IEEE 1149.4 Mixed-Signal Test Bus Working Group Meeting Minutes

March 11th, 2008
8:00 – 9:00 AM

Figure 39—Switch connections to bonding pads

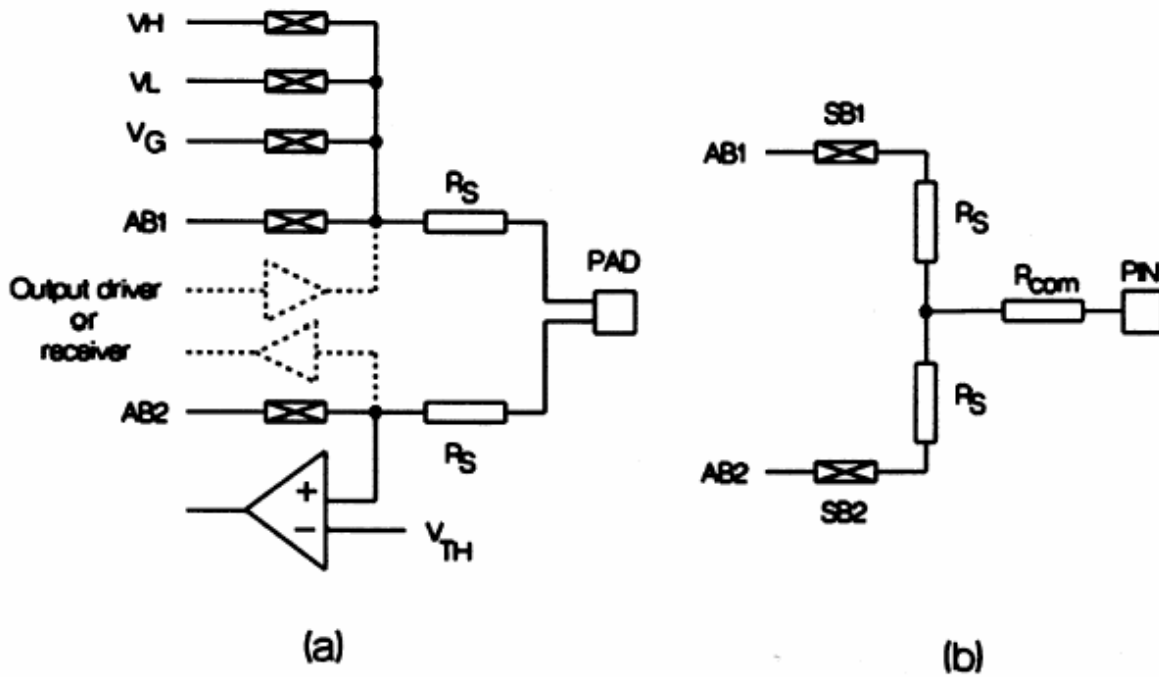
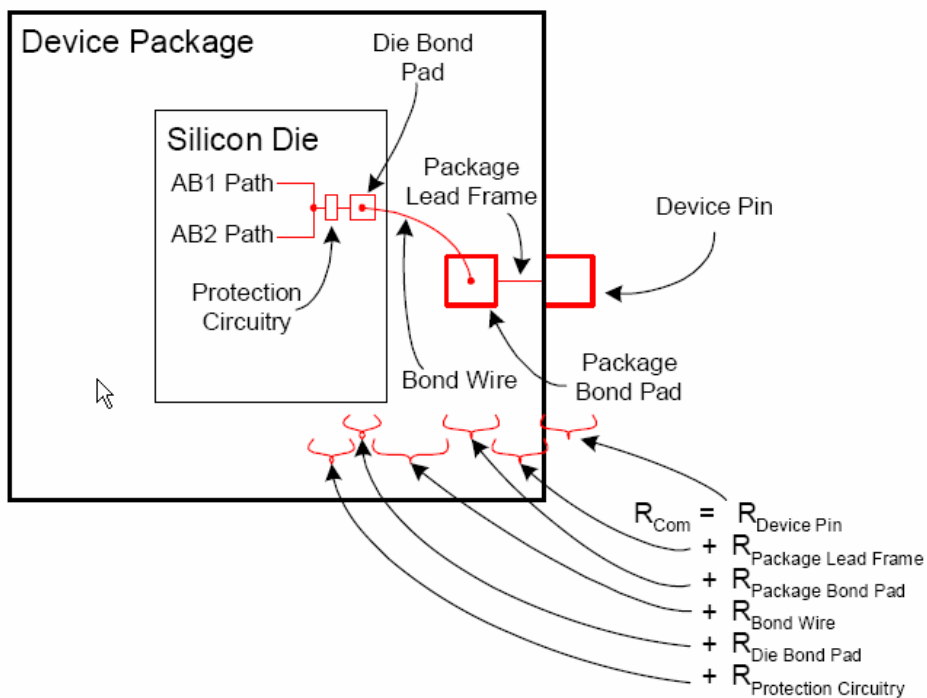
Adam Cron proposed a new single diagram as shown in the Appendix, based on the original diagram and the detail Rcom information/diagram provided by Ken.

The Rcom element has been simplified. Adam Ley was requesting a clarification on R_{S1} and R_{S2} . According to Adam Cron, both R_{S1} and R_{S2} are from the two R_S resistors in the original diagram. Although after reviewing the diagram and the description in 9.3.2, there are few things that require more clarification regarding R_S and the resistance due to the protection circuitry. The group suggested that Steve Sunter should be invited to join the next teleconference to discuss this issue.
